The latest planning applications at Cairn Gorm â?? for more hill roads and tracks (1)

Two separate planning applications have been submitted on behalf of Cairngorm Mountain Scotland Ltd (CMSL) to create new roads and tracks at Cairn Gorm both of which are currently being considered by the Cairngorms National Park Authority (CNPA). The first is for two new hill roads ([see here](#) for papers), the second is to develop â??family friendlyâ?• mountain bike trails in the lower part of Coire Cas ([see here](#) for papers) . Both applications are so poor that they deserve to be rejected outright but they also have significant implications for the future of Coire Cas. In this first post I will consider the proposal to create two new permanent roads.

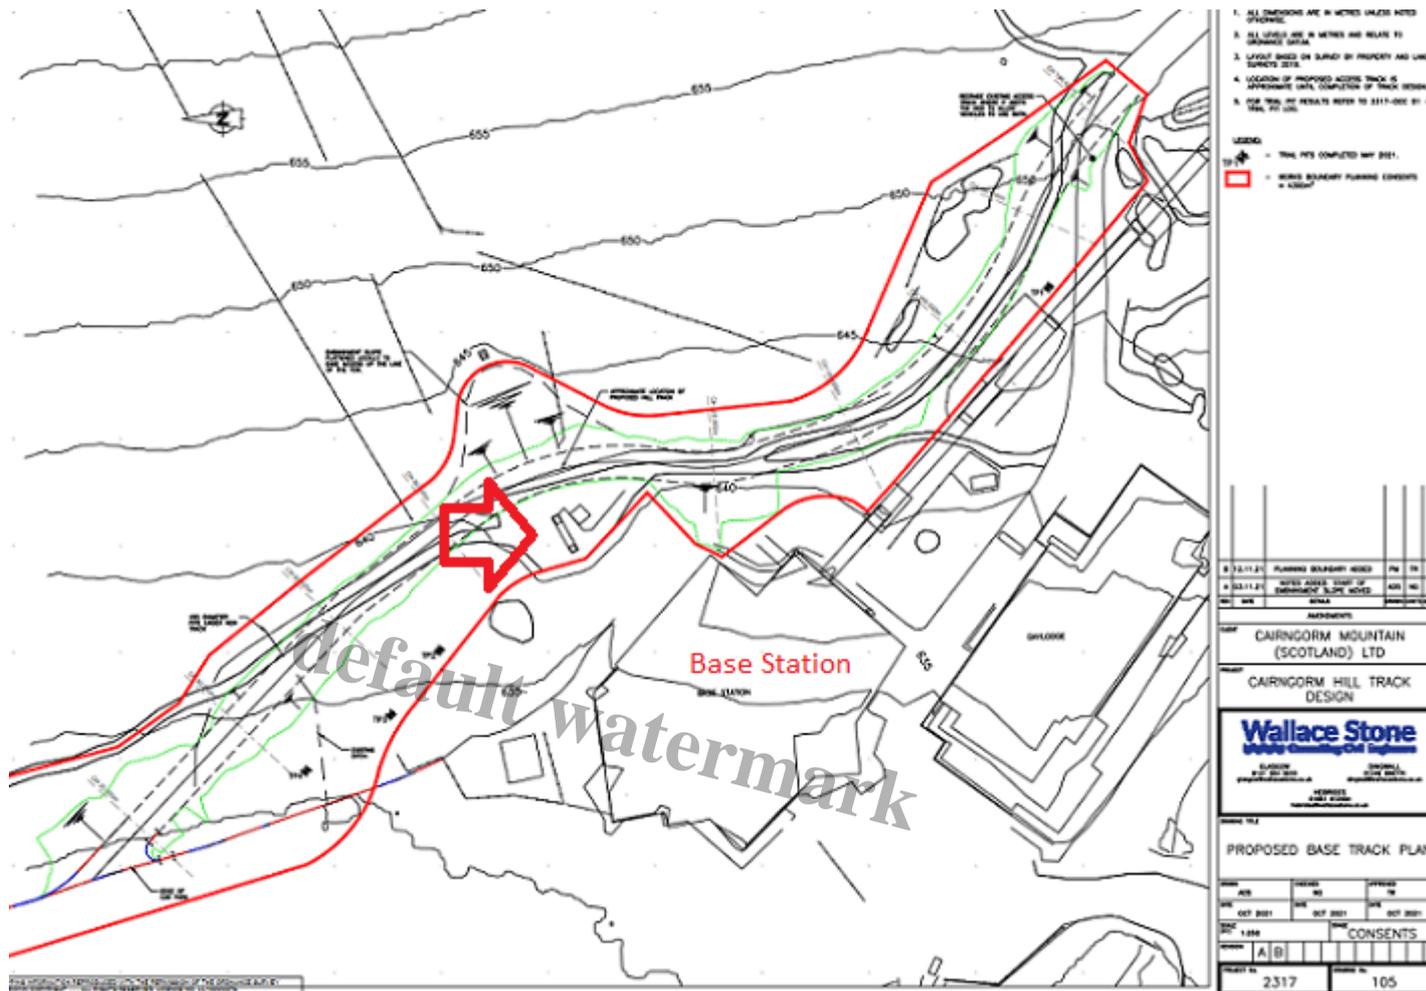
It appears therefore that CMSL is claiming that this new road is a replacement for the Aonach all-abilities trail which raises a number of questions:

- The application says nothing about how CMSL proposes to remove and restore the line of the current all-abilities trail? Unless the current road is removed, the by-pass is not a replacement but new.
- The by-pass will rise 55m to get round the Day Lodge and will be far steeper than the all-abilities trail, casting doubt about its suitability for use as an all-abilities track
- While I can find no detail of how the by-pass is to be finished, a surface suitable for all-abilities use in this location would increase its visual impact considerably.
- And in terms of the masterplan, why welcome visitors into the "orientation" area and then send them back to get onto the all-abilities path?

In truth, if the new road was really intended as a new all-abilities trail, it makes no sense.

Photo November 2018

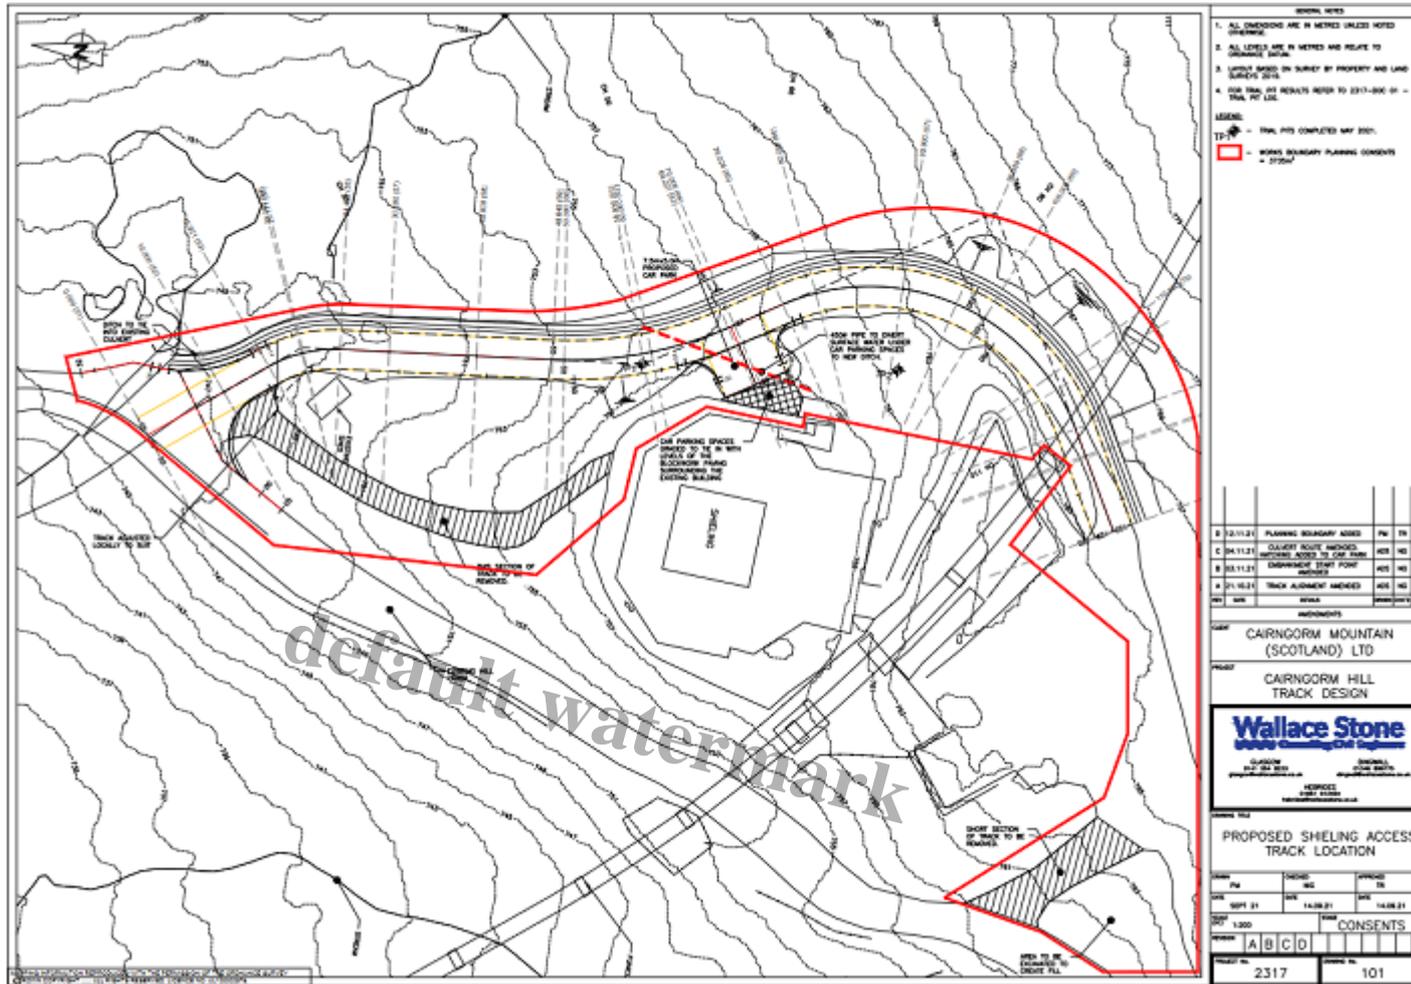
Depending on which map in the planning application you look at, the road variously passes below the Day Lodge poma drive, between it and the first tower and across the top of it!

While the plan is not properly labelled, I have added an arrow to show what appears to be the poma drive

It appears most likely that the new road, which will be over 4m wide, will pass above the Poma Drive as per the plan above. If that is the case, the clearance under the poma wires is even lower than the funicular railway so they would need to be removed each time a large load was taken up the mountain. Moreover, a larger flat area at the start of the lift would require the slope above to be re-profiled. There is no mention of this in the planning application which suggests that CMSL may now be secretly planning to remove the Day Lodge poma lift which was shown as an existing lift completely. That would fit with how CMSL has been replacing the old snow fences above the Day Lodge with a single fence.

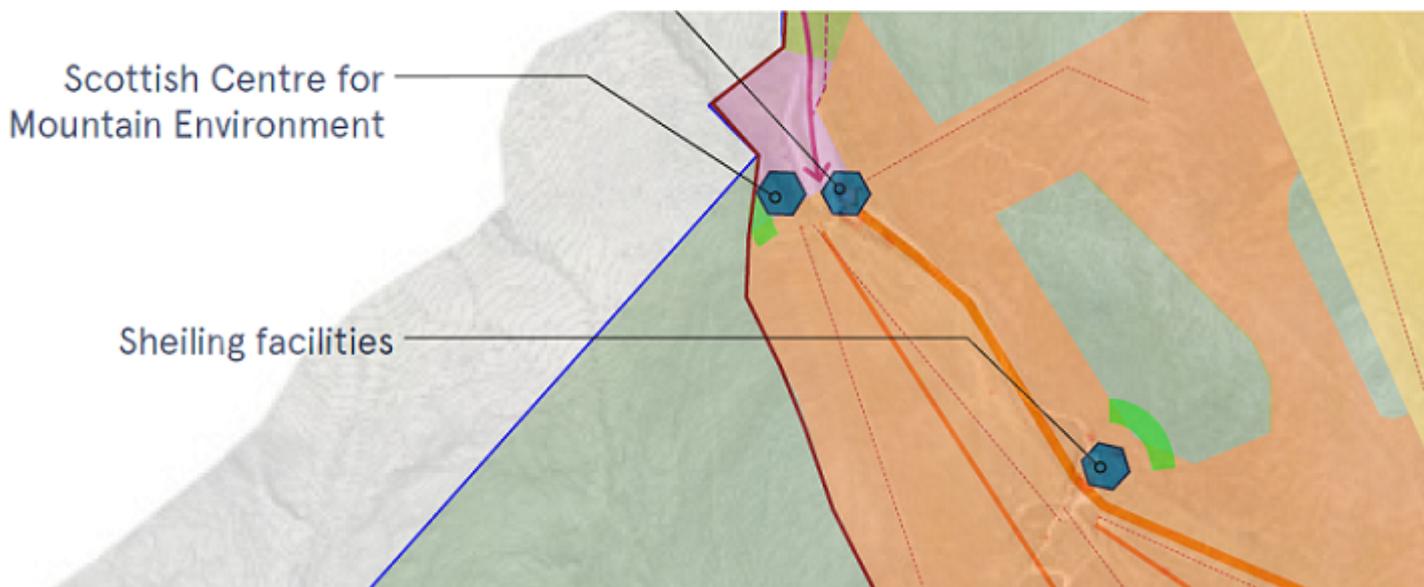
As discussed last week, it's not possible at this stage to assess the full effects of this proposal on the National Park landscape due to insufficient information submitted. Notably, no detailed description of the proposed development has been provided (although some aspects are referenced within the hydrology and hydrogeology assessment), nor a landscape and visual appraisal, or explanation of the design objectives.

They have gone on to produce a list of information that is missing/issues that need to be considered. It starts with these four points:

- a Description of routeing and design options considered, demonstrating how the proposed route minimises earthworks and represents the best option in terms of potential landscape and visual effects.
- b The routeing of the track in relation to existing features including existing tracks, paths, burns, ski tows, buildings and the funicular, with consideration of collective effects.
- c Proposed track construction materials and distinction of edges (to limit encroachment). The proposed aggregate grade and colour, and source of this. If aggregate is to be won locally, information on the siting, design and restoration of borrow pits.
- d Proposed siting and design of any new fences, bollards or signs associated with the proposed tracks.
